SUBJECT: FORWARDS RESPONSES TO NRC 790116 LTR REQUESTING ADDL INFO
 RE RADWASTE REDUCTION SYS (RWR-1).

Nine Mile Point Unit 1

RADWASTE REDUCTION SYSTEM

Additional Information

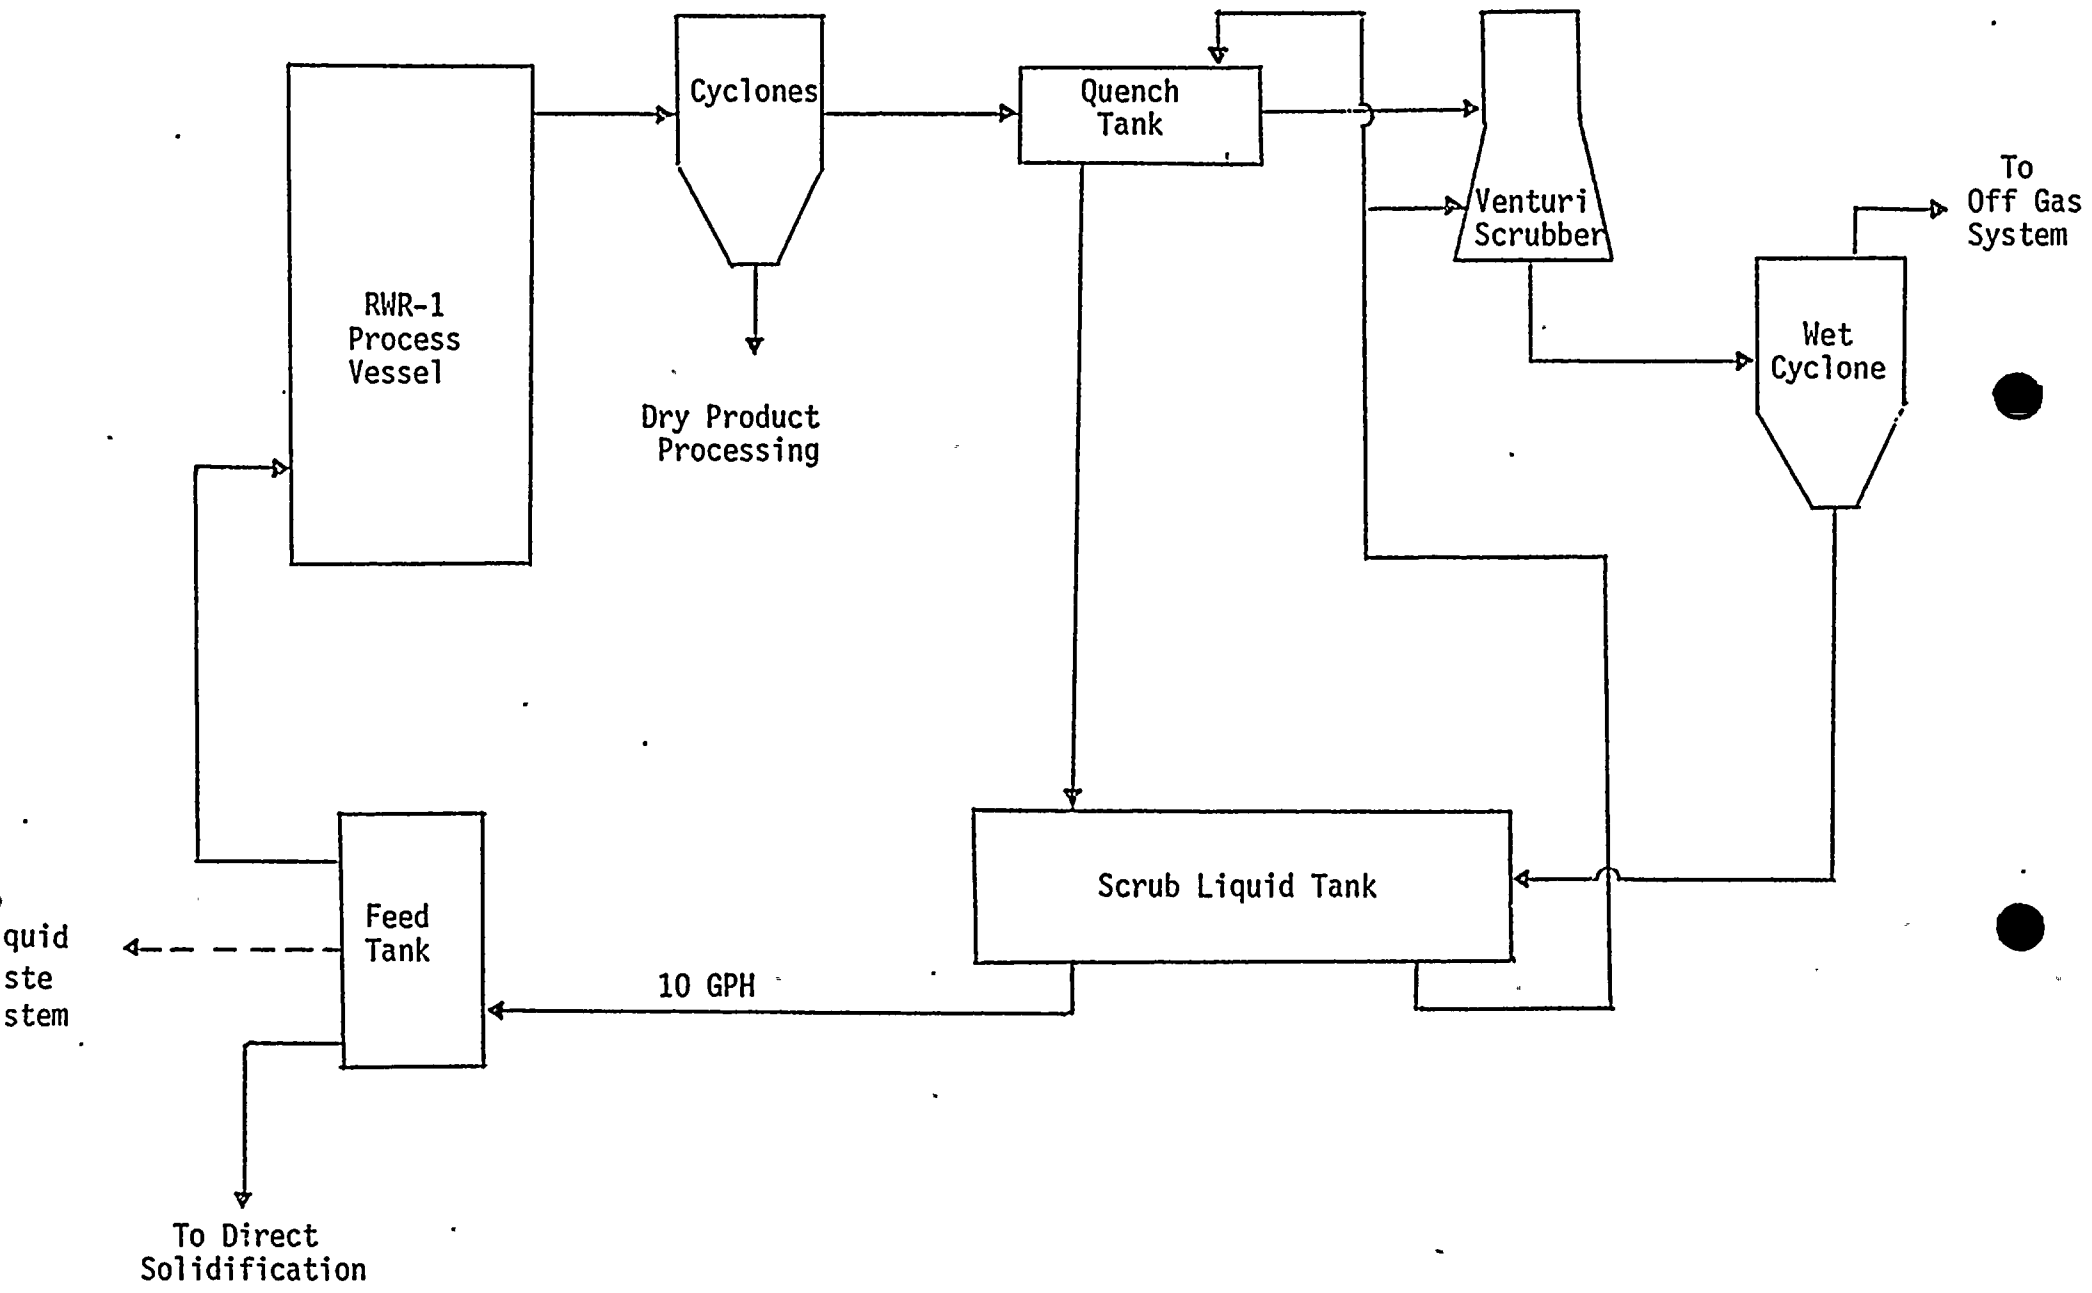
Provide an estimate of the annual volume and radionuclide distribution of the scrub liquid which is to be recycled to the liquid waste system. Describe the processing which the scrub liquid will undergo, including all alternative methods of handling, and provide justification that the liquid waste system has the capability of handling the waste volumes anticipated. Provide a flow schematic of all pathways for disposition of scrub liquid. Indicate the size of the day tank incorporated to feed the radwaste reduction system.

There will be no scrub liquid recycled to the liquid waste system on a normal basis. The scrub liquid will be discharged from the scrub liquid tank to a 2000 gallon feed tank. Flow, as shown by the attached schematic, will be a maximum of 10 gallons per hour. The liquid will have three possible pathways from the feed tank.

The normal pathway is to recycle the liquid back through the RWR-1. A backup pathway is to direct solidification.

Another alternative to be used on an emergency basis is to recycle back to the liquid waste system. This will be used, for example, in the event that the RWR-1 is not operating and maintenance in the area of the feed tank is to be performed. It is projected that this may occur on a maximum frequency of once per year. Consequently, the volume that would be recycled under these conditions would be 2000 gallons or one feed tank capacity.

The liquid waste system has the capacity to handle this volume. This liquid could be diverted to a 25,000 gallon capacity waste neutralizer tank or either of two concentrator bottoms tanks (8,000 and 12,000 gal. in capacity).

Assuming the same activity and composition as that delineated for the accident condition, the total activity in the scrub liquid would be 230 Ci in the tank volume. Since this activity was derived from processing resins in the RWR, the nuclide distribution would be the same as that indicated in Response 1.
